Magna Park Extension: Hybrid Application
APP 15/01531/OUT

**Cover Report and Summary:
Amended Application, Update of the
Environmental Statement and Supplemental
Information**

21 April 2016

Figure 2.5: The tree-lined avenue (edged red) and remaining ridge and furrow (shaded green)

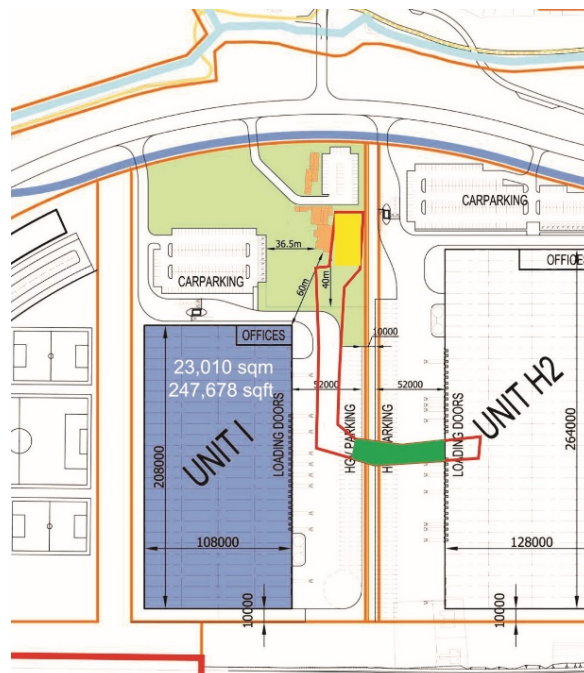
2.17 Figure 2.5 shows the boundary of the tree lined avenue and remaining ridge and furrow overlaid onto the amended illustrative masterplan.

- 2.20 These considerations were set against the implications for the wider development and its viability of retaining the avenue. As Figure 2.5 shows, both the avenue as a whole and the small area of remaining ridge and furrow (shaded green) lies across a large part of both distribution warehousing Parcels I and H. As Figure 2.5 illustrates, retaining the avenue as a whole would both effectively remove Parcel I from distribution warehousing use and substantially reduce the developable area of Parcel H; retaining just the section with the ridge and furrow would affect both parcels and also remove any context. The losses to the developable areas of H and I could not be made up by increasing the developable area in another part of the site without, at the same time, sacrificing the achievement of still more important objectives for the site’s sustainable development.

Figure 7.1: The DHL Supply Chain planning permission overlaid on the full extension site

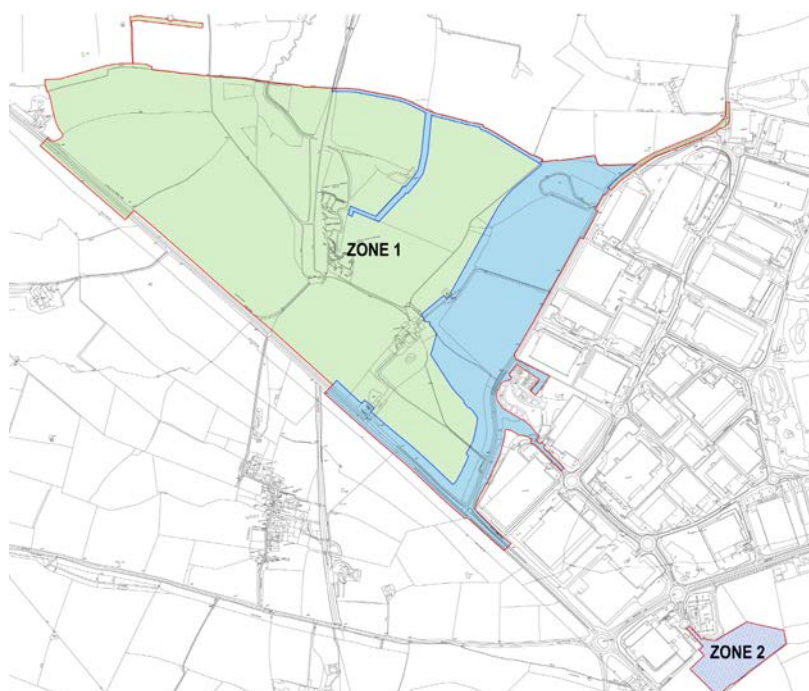
- 7.4 Figure 7.1 below shows, shaded blue, the part of the application site that has been granted planning permission for the DHL Supply Chain facility (subject to the completion of the S106). The whole site totals 55.41 ha which (like the full 230.3 ha Zone 1 extension site) includes existing parts of Magna Park (10.12 ha) and land in the public highway (6.58 ha).
